Sundry Print Report
05/19/2025

Well Name: CORRAL 22-34 FED COM	**Well Location:** T25S / R29E / SEC 22 / NWNE / 32.121102 / -103.969236	**County or Parish/State:** EDDY / NM
Well Number: 303H	**Type of Well:** OIL WELL	**Allottee or Tribe Name:**
Lease Number: NMNM14778	**Unit or CA Name:**	**Unit or CA Number:**
US Well Number: 3001556568	**Operator:** XTO ENERGY INCORPORATED

Procedure Description: XTO ENERGY INCORPORATED respectfully requests approval to make the following changes to the approved APD. Changes to include well name. The proposed well name is changing from Corral 22-34 Fed Com 303H to Corral 22-34 Fed Com 306H The API number for this well is 30-015-56568.

Procedure Description: XTO Energy Inc. respectfully requests approval to make the following changes to the approved APD. Changes include SHL, KOP, FTP, LTP, BHL, Proposed total depth, Pool, and dedicated acreage, Formation TVD, Casing Design, Cementing Program, Mud Program. APD ID 10400098702. Well API Number is : 30-015-56568 FROM: TO: SHL: 603' FNL & 1705' FEL OF SECTION 22-T25S-R29E 604' FNL & 1705' FEL OF SECTION 22-T25S-R29E KOP: 603' FNL & 1705' FEL OF SECTION 22-T25S-R29E 616' FSL & 1501' FEL OF SECTION 1

C-102
Revised July 9, 2024
Submit Electronically
via OCD Permitting

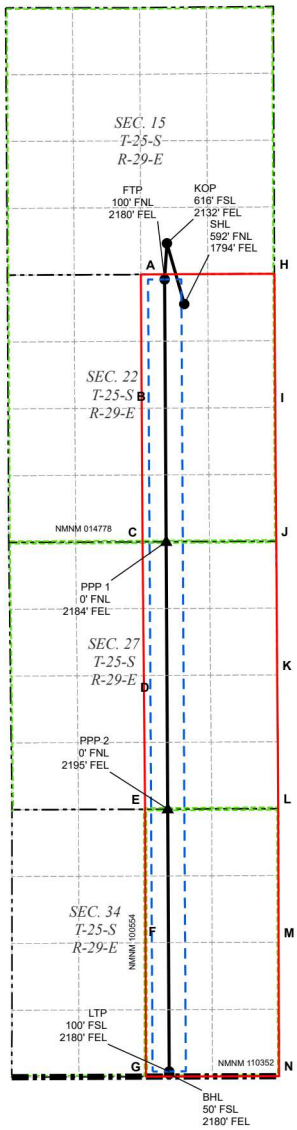
The proposed well name is changing from Corral 22-34 Fed Com 303H to Corral 22-34 Fed Com 306H
The API number for this well is 30-015-56568.

C-102
Revised July 9, 2024
Submit Electronically via OCD Permitting

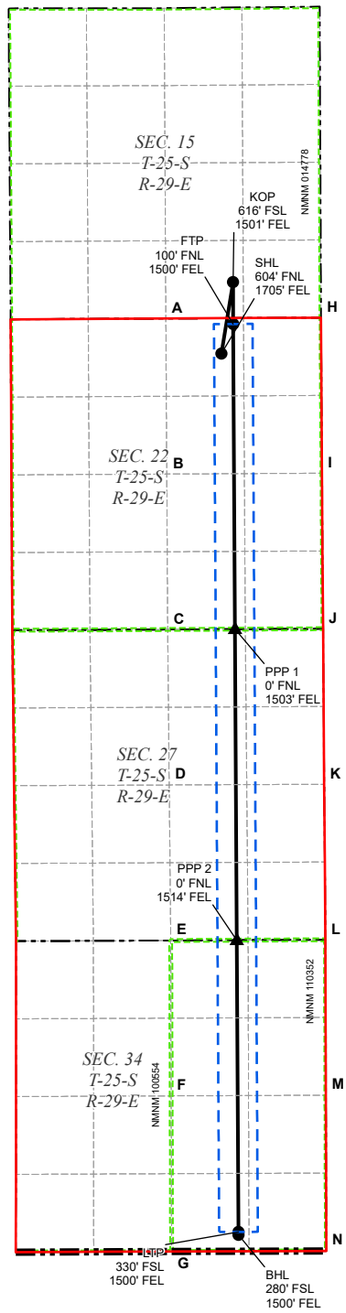
The pool is changing from WILLOW LAKE, BONE SPRING, SOUTHEAST to PURPLE SAGE; WOLFCAMP (Gas)

The dedicated acreage is changing from 960.00 to 1920.00.

UL	Section	Township	Range	Lot	Ft. from N/S	Ft. from E/W	Latitude	Longitude	County
B	22	25S	29E		604 FNL	1,705 FEL	32.121102	-103.969236	EDDY

UL	Section	Township	Range	Lot	Ft. from N/S	Ft. from E/W	Latitude	Longitude	County
O	34	25S	29E		280 FSL	1,500 FEL	32.079740	-103.968458	EDDY

UL	Section	Township	Range	Lot	Ft. from N/S	Ft. from E/W	Latitude	Longitude	County
O	15	25S	29E		616 FSL	1,501 FEL	32.124457	-103.968583	EDDY
